MONACO
COACH CORPORATION

VEHICLE SAFETY DEFECT SERVICE BULLETIN

Recall Campaign
USA 05V053000 / CANADA 05-036
Monaco File # RO4062

Re: Safety Recall - Rear Trailing Arms & U-Bolts - Revised Inspection Procedure

Figure 1

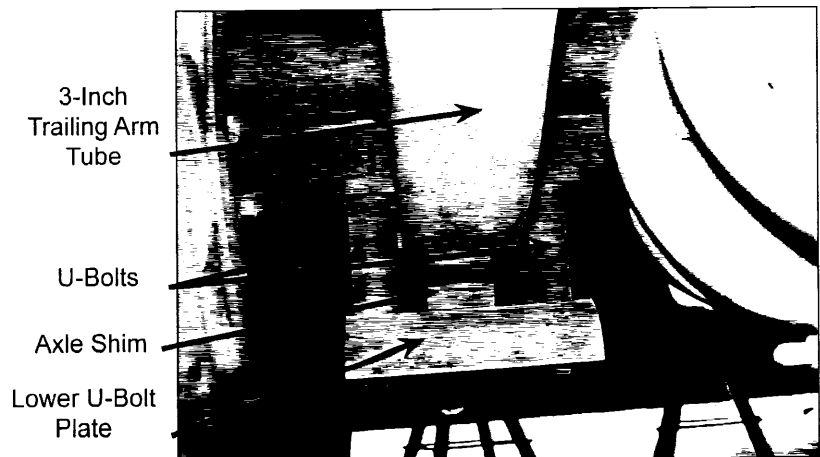
- Park the coach on a flat level surface. Turn the engine off, set the park brake and chock the wheels.
- Slide under the coach in front of the rear wheels.
- Locate the Axle shim between the 3-inch Trailing Arm Tube and the Lower U-bolt Plate (see Figure 1).

Figure 2a

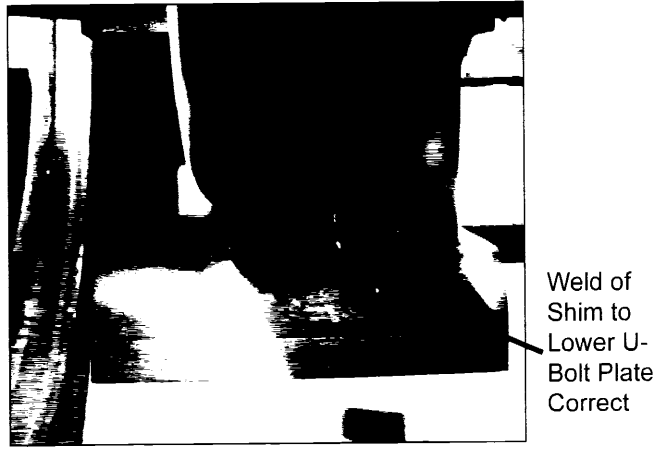
A. If the Axle Shim is welded on the upper side to the 3-inch Trailing Arm, the Trailing Arm needs to be replaced (see Figure 2a). If the Axle Shim is welded on the lower portion to the Lower U-bolt Plate, the Trailing Arm does not need to be replaced (see Figure 2b).
